Business Class M2
 > Cascadia
 108SD/114SD
 > New Cascadia

Caster Angle

Fig. 1, Caster Angle

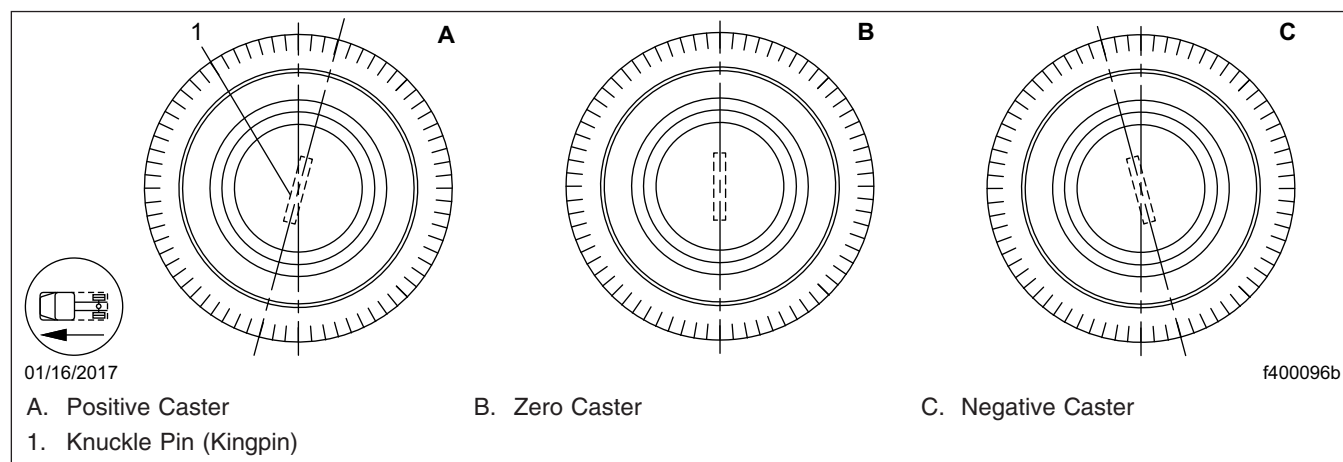
The caster angle specifications are different for Cascadia and New Cascadia. When aligning a New Cascadia vehicle, use the appropriate values shown in **Table 1**. The target values indicate a positive caster angle; see **Fig. 1**.

Caster Angle Specifications				
Side	Cascadia		New Cascadia	
	Target (degrees)	Tolerance (degrees)	Target (degrees)	Tolerance (degrees)
LH	3.5*	±1.5	4.5	±1.5
RH	3.5*	±1.5	4.5	+3.5/-1.5

* LH and RH values must be within 0.5 degrees of each other (Cascadia only).
